Source: T1
Title: Summary of TTCN CRs B category to 34.123-3 for approval
Agenda item: 6.1.3
Document for: Approval

This document contains the TTCN CRs B category to 34.123-3. These CRs have been agreed by T1 and are put forward to TSG T for approval.

Title:	# Addition of WI-12 test cases 8.1.2.13 to IR_U ATS v3.8.0		
Source:	# Aeroflex		
Work item code:	# N/A	Date:	# 11/02/05
Category:	# B	Release:	# R99
	Use <u>one</u> of the following categories: F (correction) A (corresponds to a correction in an earlier release) B (addition of feature), C (functional modification of feature) D (editorial modification) Detailed explanations of the above categories can be found in 3GPP TR 21.900 .		Use <u>one</u> of the following releases: 2 (GSM Phase 2) R96 (Release 1996) R97 (Release 1997) R98 (Release 1998) R99 (Release 1999) Rel-4 (Release 4) Rel-5 (Release 5) Rel-6 (Release 6)

4 Corrections required for test case 14.2.9

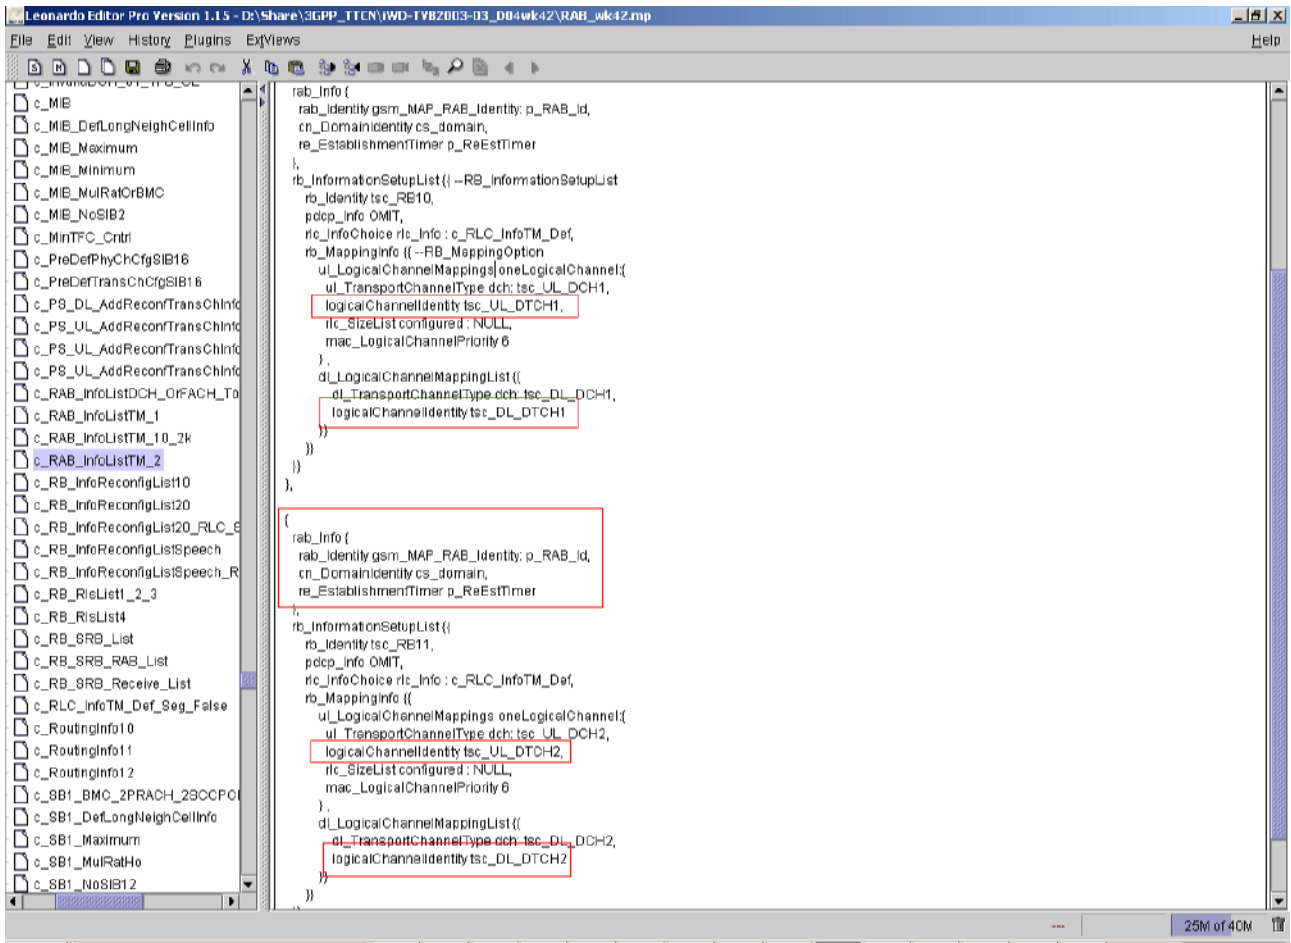
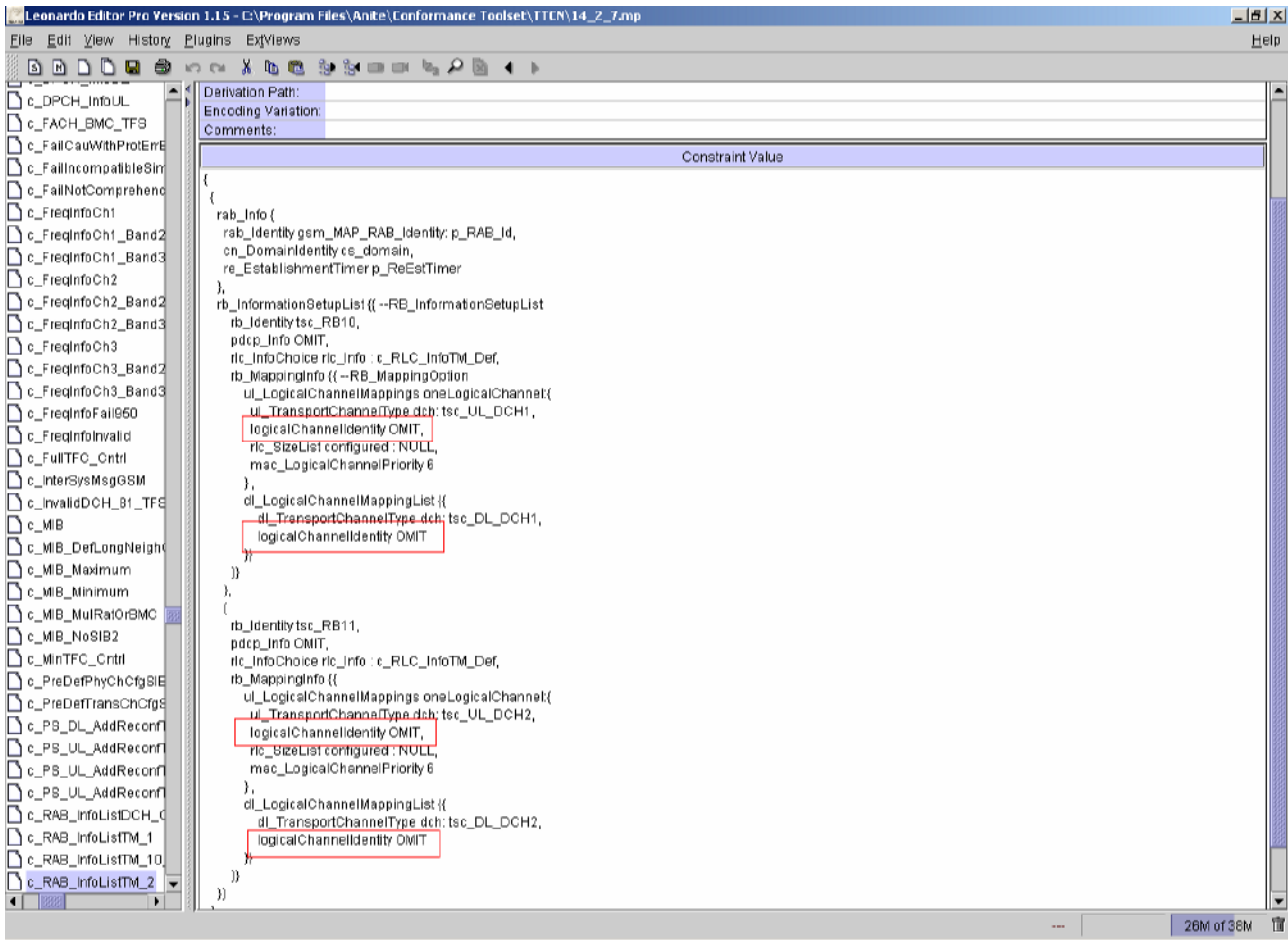
Constraint	c_RAB_InfoListTM_2
Reason for change	<ol style="list-style-type: none">1) As per the 34.108 the IE "logicalChannelIdentity" should be omitted, however in the TTCN the IE "logicalChannelIdentity" is present.2) In TTCN for RB 11 IE "rab_info" is defined again. However as RB 10 and RB 11 are part of the same RAB ('00000001'B), thus IE "rab_info" need not be repeated for RB 11.
Summary of change	<ol style="list-style-type: none">1) In constraint c_RAB_InfoListTM_2, the IE "logicalChannelIdentity" is changed to "OMIT" for RB 10 & RB11.2) IE "rab_info" is removed for RB 11.
Source of change	New change
